ADDENDUM NO. 3 – July 15, 2026

Mossdale Wastewater Pump Station Access Modifications and Upgrades CIP WW 26-09

This addendum amends the Contract Drawings and Specifications for this project as follows:

H SECTION
SCALE: 1/2"=1'-0"

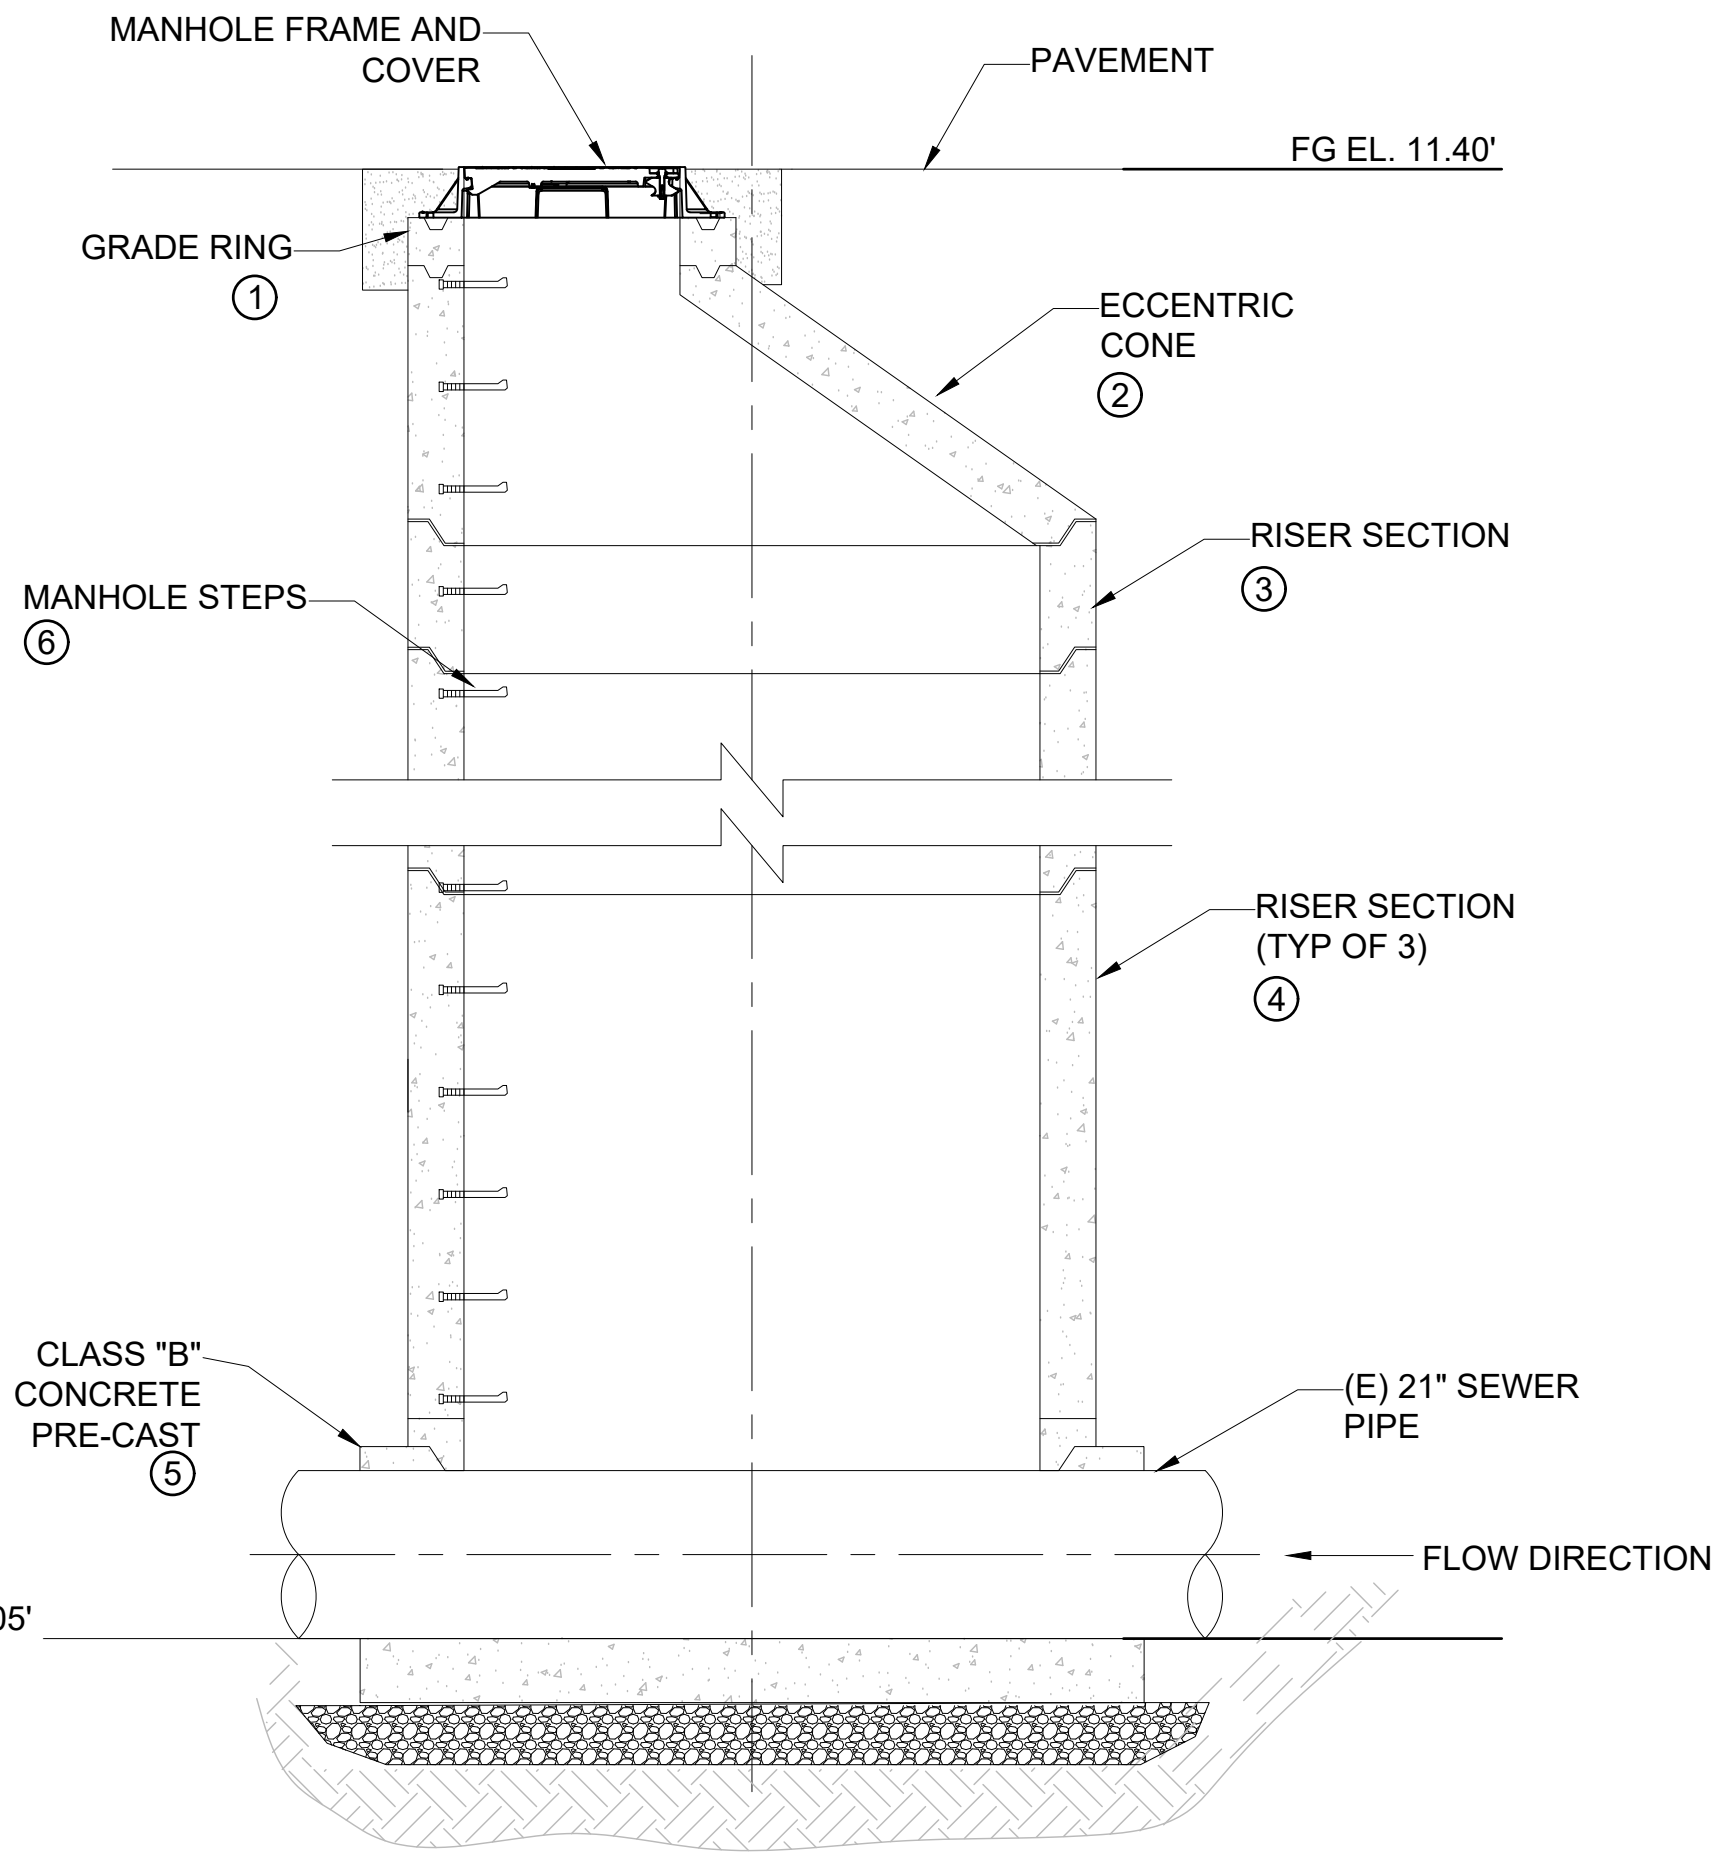
1. See Attachment A, new and amended plan sheets for construction of a bypass with manhole.
2. See Attachment B, new and revised Bidding and General Requirements and Technical Specifications for the construction of a bypass and manhole.
3. See Attachment C, Revised Bid Schedule, CIP WW 26-09. **All bids must be submitted on the revised bid schedule.**
4. Contract Time: The Contract Time is increased by 75 working days, for a revised total of 150 working days.
5. Supplementary Conditions 00800-2 and 00800-3 are revised as follows:

- ASSUMPTION: DISTANCE FROM INVERT AT PUMP STATION TO MH LOCATION: 16'-2" @ 2% SLOPE $\approx$ 0.325'. PIPE INVERT ELEVATION @ MANHOLE = -13.605'. ACTUAL PIPE SLOPE UNKNOWN. NEW MH ELEVATION SHALL PROVIDE FOR POSITIVE FLOW THROUGH TO PUMP STATION.

- BYPASS SANITARY SEWER MANHOLE SHALL BE CONSTRUCTED IN ACCORDANCE WITH CITY STANDARD DRAWING S-1.
- PRECAST REINFORCED CONCRETE MANHOLE UNIT SHALL CONFORM TO ASTM C-478.

1 BYPASS PLAN VIEW
SCALE: 3/32"=1'-0"

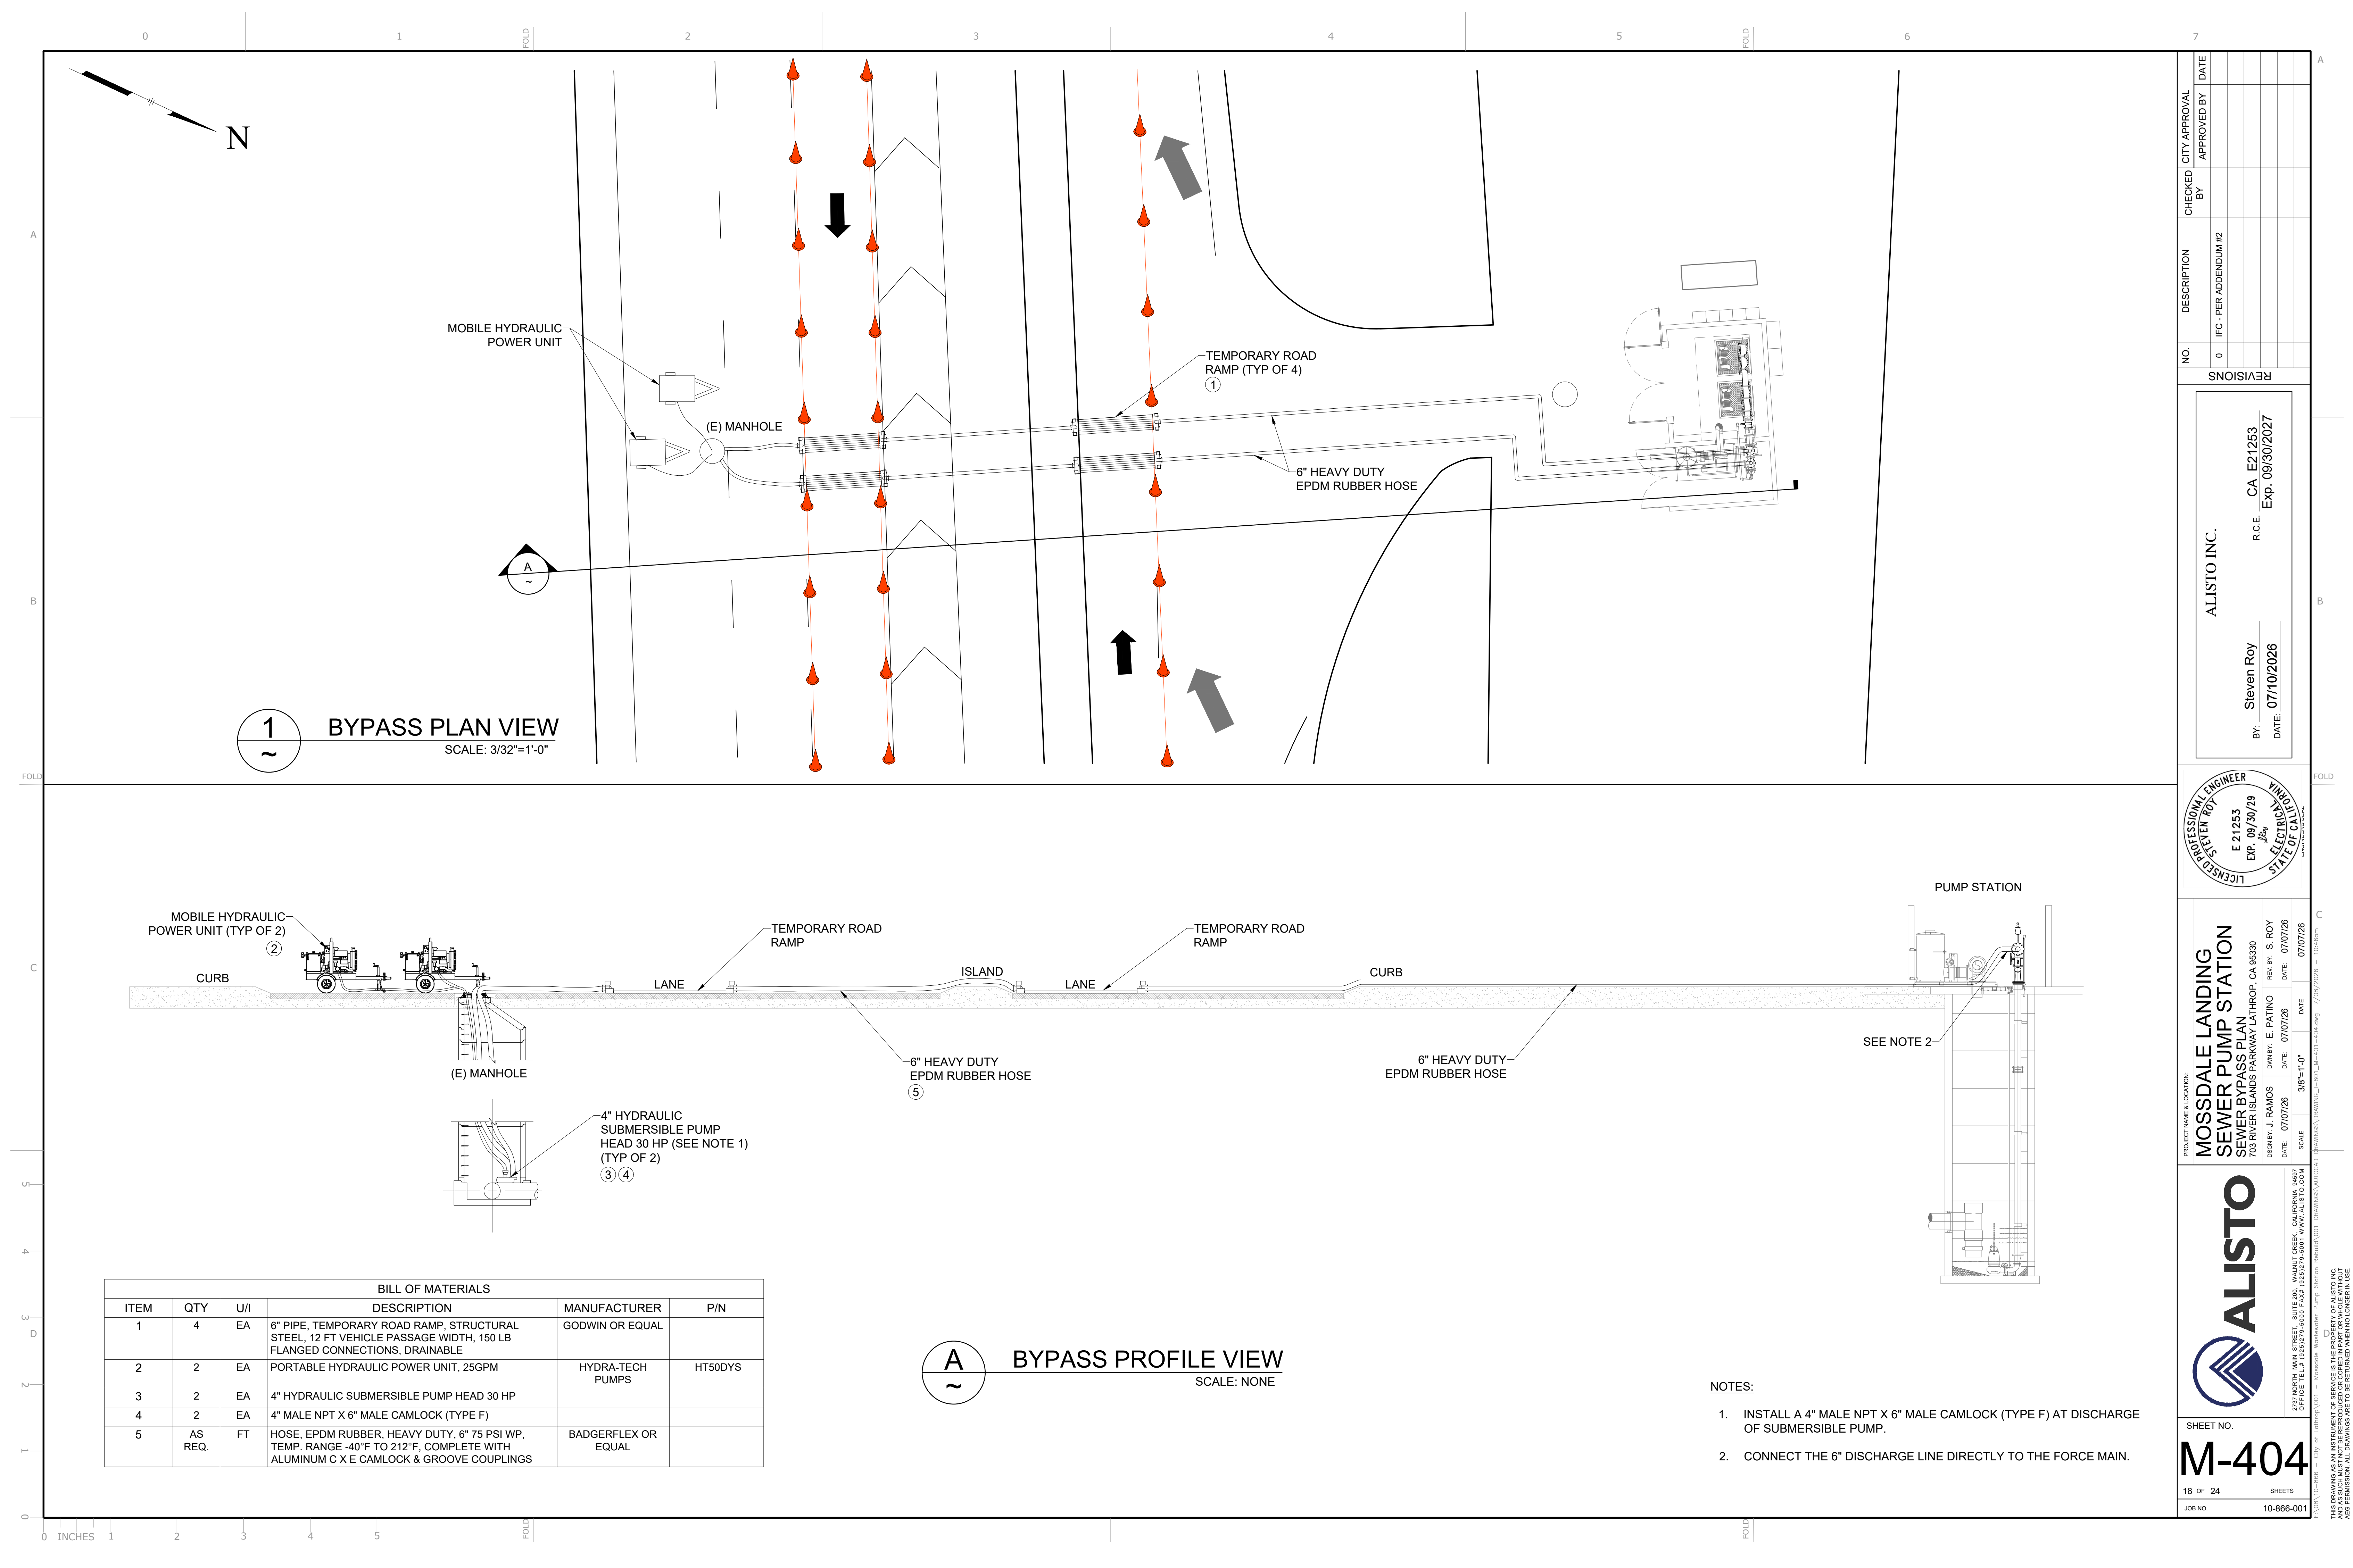
RFI 8: Where are the allowed locations for the contractor to utilize for temporary bypass suction & discharge. Additionally, please provide the peak flow and TDH requirements for said temporary bypass.

A8: Inclusion of a new manhole to be constructed in concert with the Mossdale Pump Station inspection, restoration, and upgrade project proposal can provide an opportunity to reduce the impact of pumping from the wastewater system manhole located on the South side of River Islands Parkway, across from 703 River Islands Parkway and encumbering both directions of travel. Neither the interior wetwell work nor the new manhole construction can be performed without bypass pumping of effluent from the sanitation system around the wetwell or new manhole work areas. Work to inspect and restore the wetwell as well as demolition of the roof and other prescribed MCC and station improvements can be performed at the discretion of the CONTRACTOR during the construction of the new manhole located at the entrance of the 703 River Islands Parkway Pump Station. It may benefit of the contractor to sequence work to take place in the wetwell after the manhole construction is complete enough to allow for bypass pumping to take place from the newly constructed manhole (to the 10" and 8" force main connections on the west side of the pump station). Consideration of this alternative must include the consequence of the manhole construction taking place directly in front of the single access gateway to the pump station.

The communicated bypass pumping plan provides approximately 175 feet of horizontal distance and approximately 30 vertical feet from the existing manhole, across several lanes of vehicular traffic, and to the force main header at the pump station. CONTRACTOR must determine and provide pump and hose requirements providing for peak flow demand of 600 gpm and maintain a redundant pump and hose system to provide immediate standby in case of primary pumping failure. The sanitary main is 21" diameter PVC at the invert of both the existing and the to-be-constructed manhole. CONTRACTOR may use the new manhole for the pumping around the wetwell portion of the WORK at his discretion. Construction of the new manhole will require bypass pumping of effluent from the South side of River Island Parkway to the force main header from when the existing 21" sewer line is sectioned to allow placement of the manhole base, construction of the MH invert and re-connection to the upstream sewer pipeline. The pumping considerations remain the same though the distance for hose will reduce to approximately 30 horizontal feet and approximately 30 feet of head. The advantage of less inconvenience to the traveling public by moving the pumping from the existing manhole to the new manhole is noted and desirable.
